ORLANDO UTILITIES COMMISSION

Re: Orlando Utilities Commission SEC Unit No. 2 BACT (PSD-FL-084)

FDER - Question 36

Figure 1 COAL SHIPMENTS

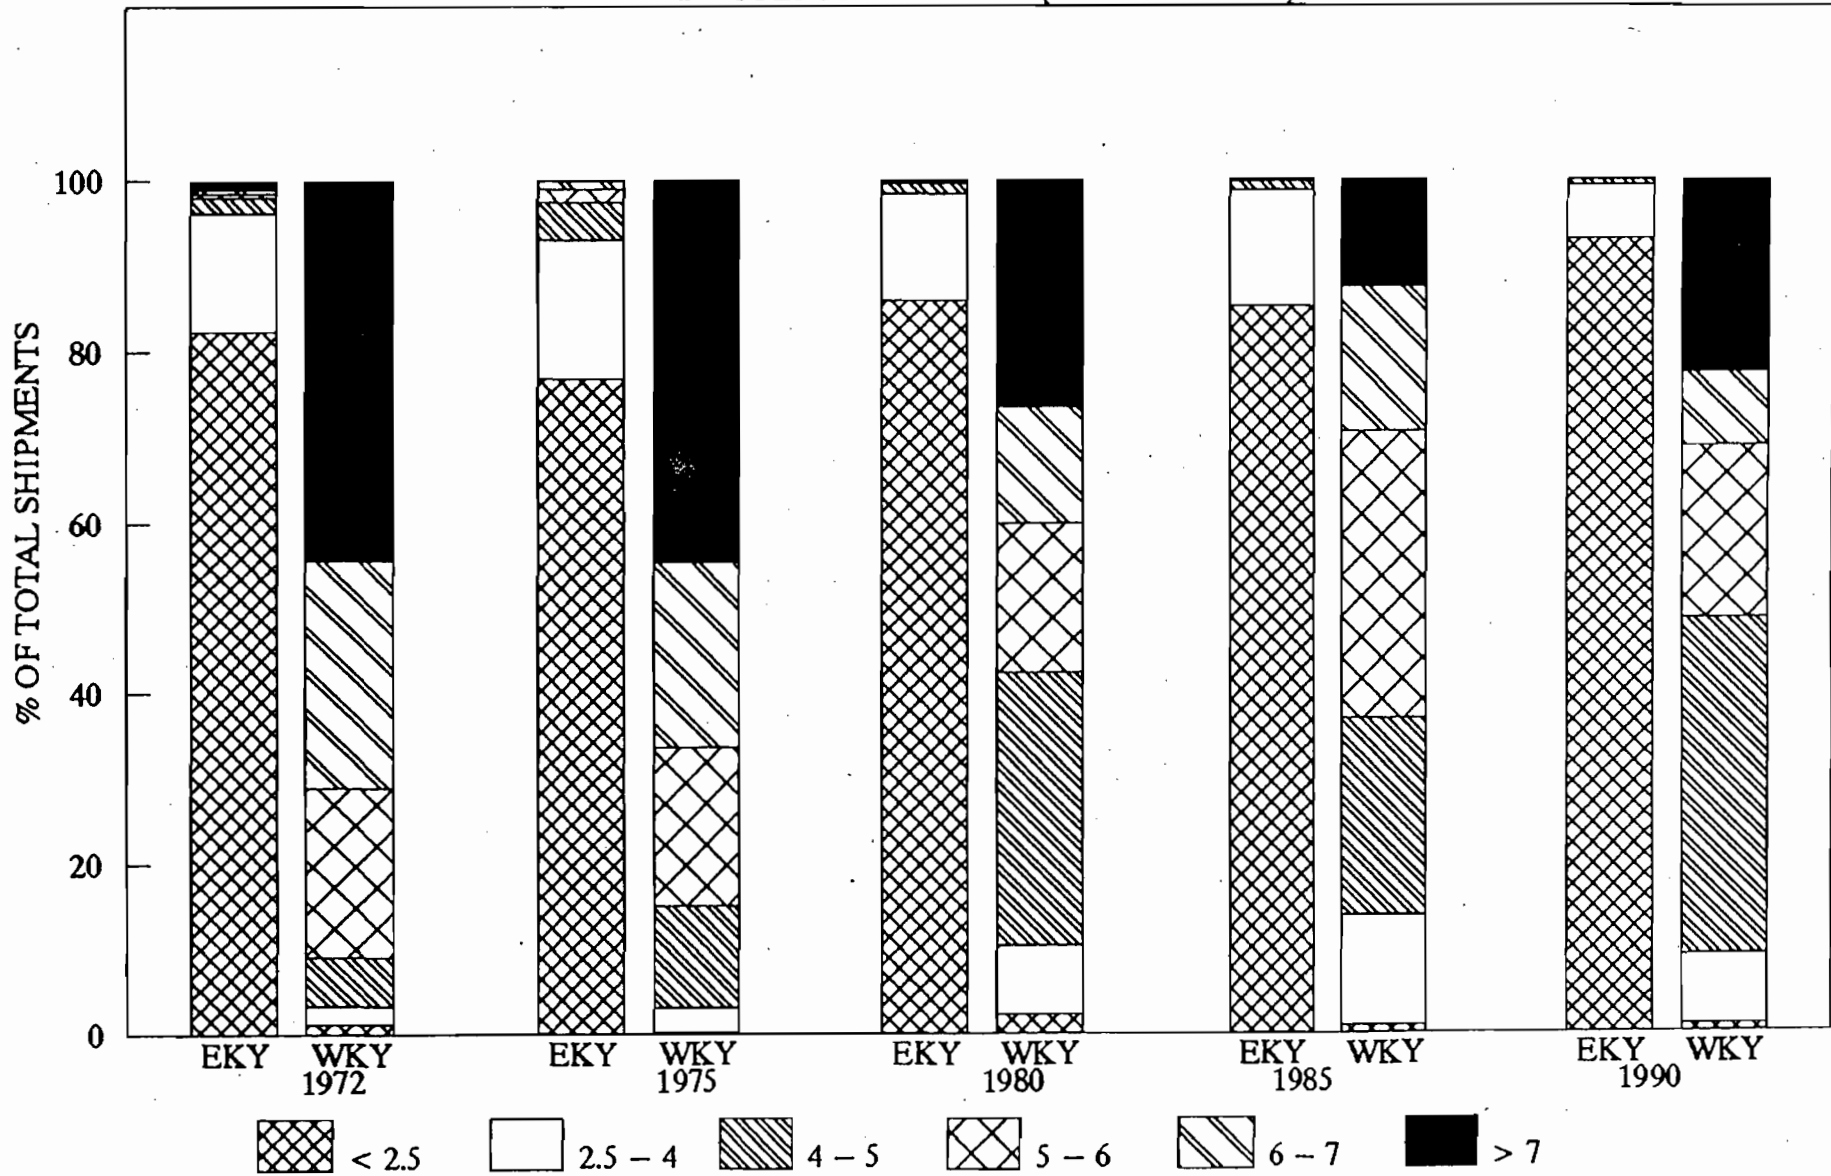
Question. BACT analysis for Sulfur Dioxide should evaluate the use of lower sulfur content coals. Recent permitting evaluations have limited the sulfur content of coal to 1.7 percent for CFB boilers and to 2.0 percent for pulverized coal fired boilers.

The attached Table 1 shows the coal reserve base for East Kentucky, Virginia, West Kentucky and Illinois by sulfur content. This table shows that the majority of coals in East Kentucky and Virginia have less than 1 percent sulfur. On the other hand the majority of coals from West Kentucky and Illinois have sulfur contents greater than 3 percent. The attached Figure 1 shows the sulfur dioxide emission potential of coal shipments from West Kentucky and East Kentucky for the period 1972 to 1990. It is seen that the majority of shipments from East Kentucky (90 percent in 1990) are less than 2.5 lbs SO₂/MBtu while the majority (90 percent in 1995) of shipments from West Kentucky are greater than 4 lbs SO₂/MBtu. It is therefore seen that there is a "quality chasm" between the higher sulfur coals of West Kentucky (> 4 lb SO₂/MBtu) and

The coal qualities described in question 53 (1.7 to 2% sulfur) with SO₂ emission potentials of less than 3 lbs SO₂/MBtu, would have to be satisfied by East Kentucky coals having emission potentials of less than 2.5 lbs SO₂/MBtu.

SULFUR DIOXIDE EMISSION POTENTIAL OF COAL SHIPMENTS

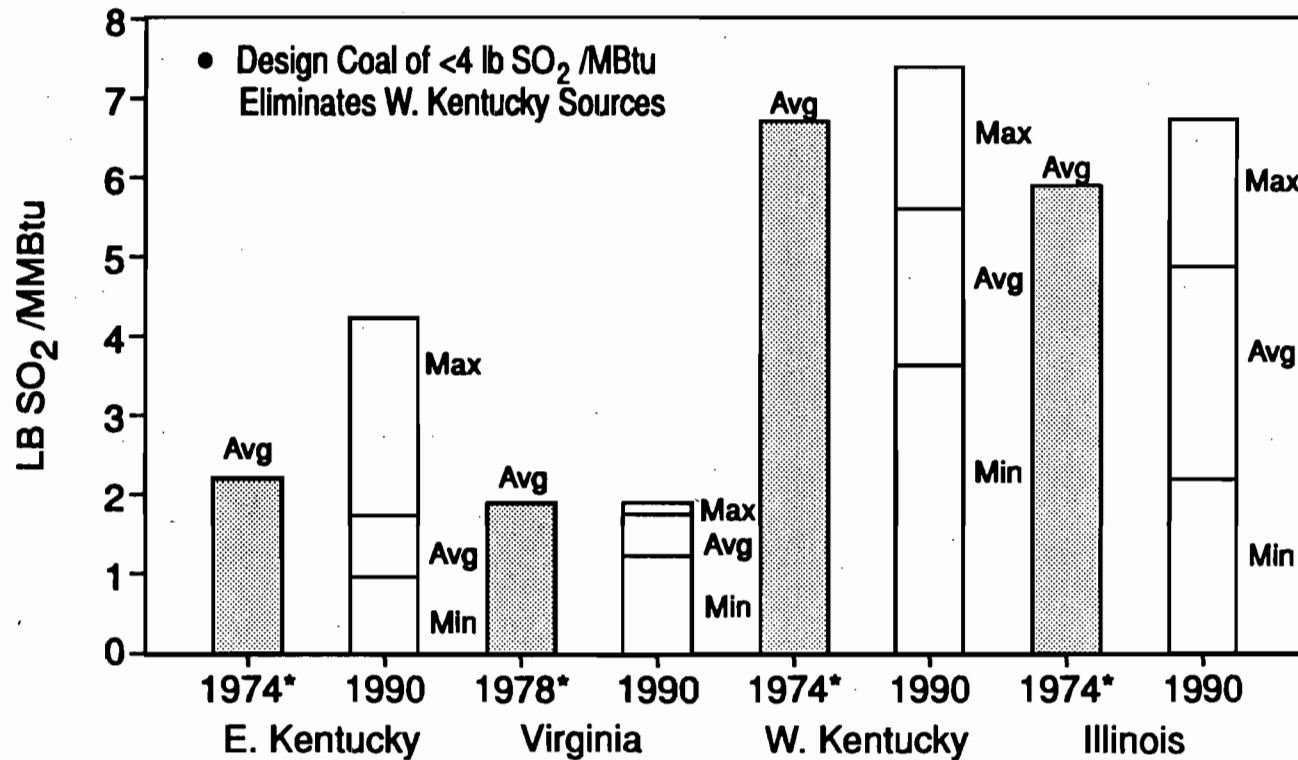
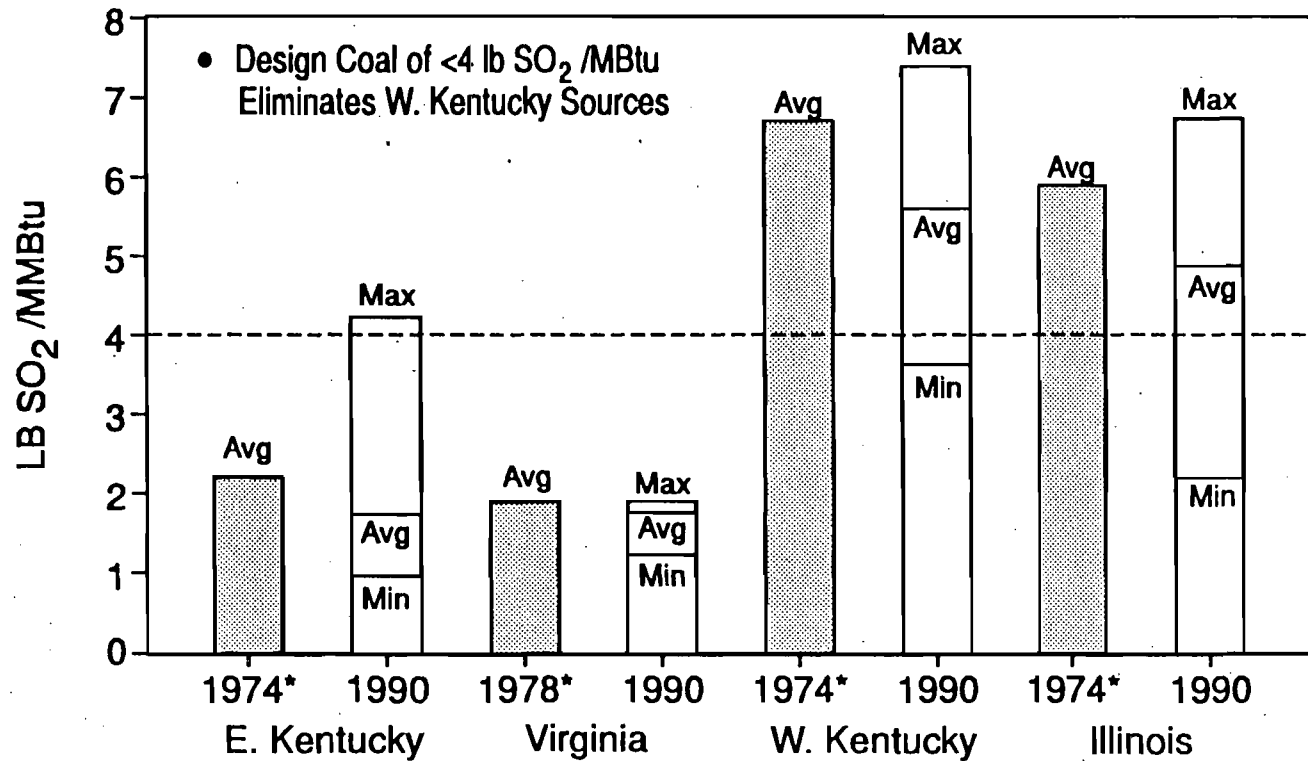
Enclosed are copies of the slides presented. One of the slides on Potential SO₂ Emissions presented by Mr. Ken Carlson was corrected to include a footnote. During Mr. John Cochran's presentation on SNCR, costs were presented in terms of dollars per ton of NO_x removed. Additional costs reflecting reduced plant availability^x were not available at the time of presentation and have been included as an additional slide.
